Office Action Summary	Application No. 10/590,902	Applicant(s) AKABA ET AL.
	Examiner HUNG NGUYEN	Art Unit 3742

DETAILED ACTION

Fig. 2

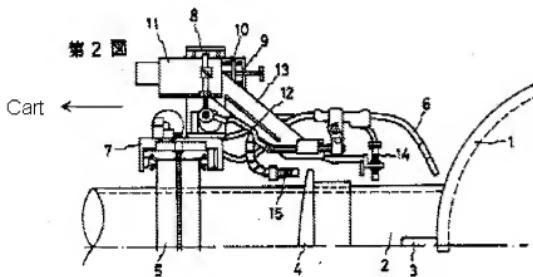
6. Oki discloses an apparatus for improving residual stress of piping, the T-piping comprising a first piping 2 (Fig. 2 below) having one end welded and connected to a tubular circumferential surface of a second piping 1 (Fig. 2 below), and comprising: a circumferential-direction position adjusting structure for moving the welding head 6 (fig. 2 below) along a circumferential direction about a tubular axis of the first piping 2 (Circular axis of pipe 2, Fig. 2 below); a tubular axial-direction position adjusting structure for moving the welding head 6 (Fig. 2 below) along a tubular axial direction of the first piping (Vertical axis of pipe 2, Fig. 2 below); a radial-direction position adjusting structure for moving the welding head 6 (Fig. 2 Below) along a radial direction of the first piping (Horizontal axis of pipe 2, Fig. 2 below); wherein the circumferential-direction position adjusting structure includes a rail mounted 5 (Fig. 2 below) on a surface of the first piping 2 (Fig. 2 below), wherein the rail 5 (Fig. 2 below) includes a ring shape surrounding a periphery of the first piping 2 (Fig. 2 below), and wherein the circumferential-direction position adjusting structure further includes a cart (Fig. 2 below) traveling on the ring-shaped rail 5 (Fig. 2 below) as a track.

Oki does not disclose irradiating an outer surface of a T-piping with a laser beam emitted from a laser head and an emission-direction adjusting structure for changing an emission direction of the laser beam in a plane including the tubular axis of the first piping, by changing a direction of the laser head; and a second emission-direction

adjusting structure for changing the emission direction of the laser beam in a plane intersecting the plane including the tubular axis of the first piping, by changing the direction of the laser head.

It would have been obvious to one of ordinary skill in the art at the time of the invention was made to utilize in Oki, improving residual stress of piping, which irradiates an outer surface of a T-piping with a laser beam emitted from a laser head and an emission-direction adjusting structure for changing an emission direction of the laser beam in a plane including the tubular axis of the first piping, by changing a direction of the laser head; and a second emission-direction adjusting structure for changing the emission direction of the laser beam in a plane intersecting the plane including the tubular axis of the first piping, by changing the direction of the laser head, as taught by Wegener, for the purpose of preventing stress-corrosion-cracking at the T-piping connection.
